DRAFT
CLOSURE PLAN
FOR
RIDGEFIELD BRICK AND TILE SITE
RIDGEFIELD, WASHINGTON

JULY 15, 1983

PACIFIC WOOD TREATING CORPORATION
110 WEST DIVISION STREET
RIDGEFIELD, WA 98642

SWEET, EDWARDS & ASSOCIATES, INC.
P.O. Box 328
KELSO, WA 98626

FIGURE 12

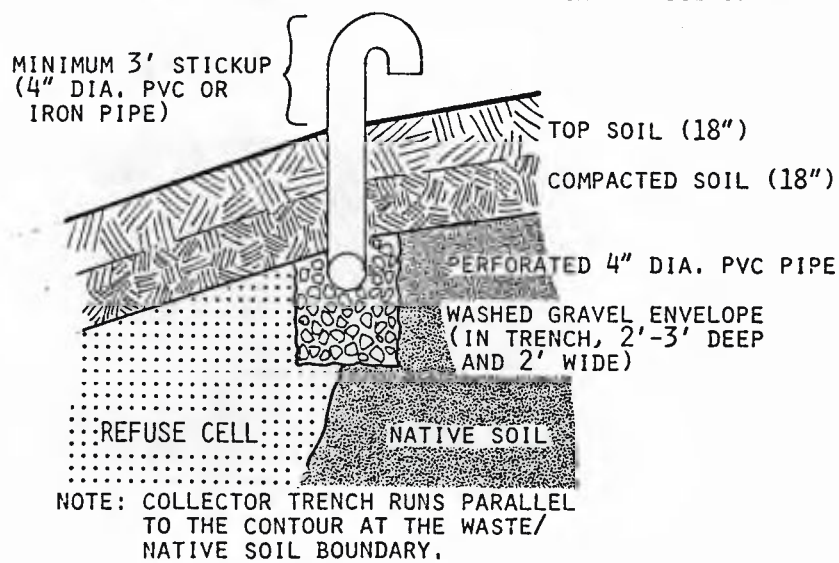
- 7) Install passive gas venting system to include three vertical standpipes connected to a perforated horizontal collector encased in a washed gravel envelope as shown on Figure 12.
